Uptown Ankeny Lofts 719 SW 3rd Street

*Plan and Zoning Commission
Staff Report*

Agenda Item: Uptown Ankeny Lofts - Site Plan
Report Date: November 15, 2017
Prepared by: Deb Gervais, AICP
Associate Planner

**Site Plan Worksheet
Uptown Ankeny Lofts**

TRASH ENCLOSURE

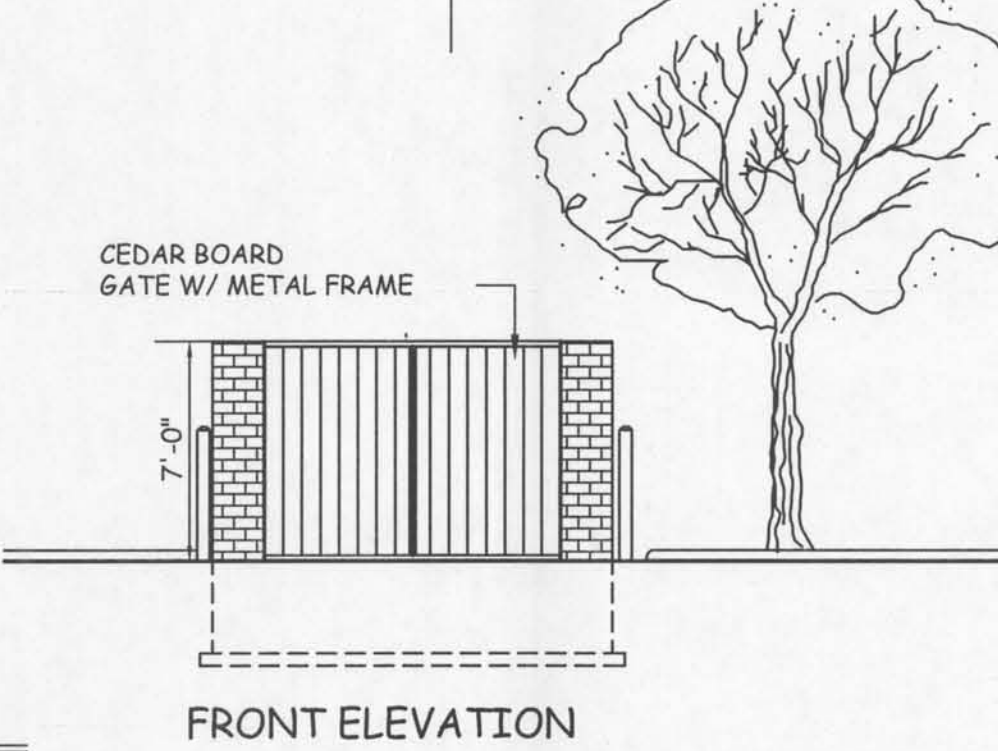
A screened trash enclosure is located to the south and west of the proposed multi-tenant building. The trash enclosure will be constructed of face brick with a wood gate.

The trash enclosure will be located to the southwest of the proposed multi-tenant building and will be constructed of face brick with a cedar wood gate. All rooftop units will be screened by parapet walls.
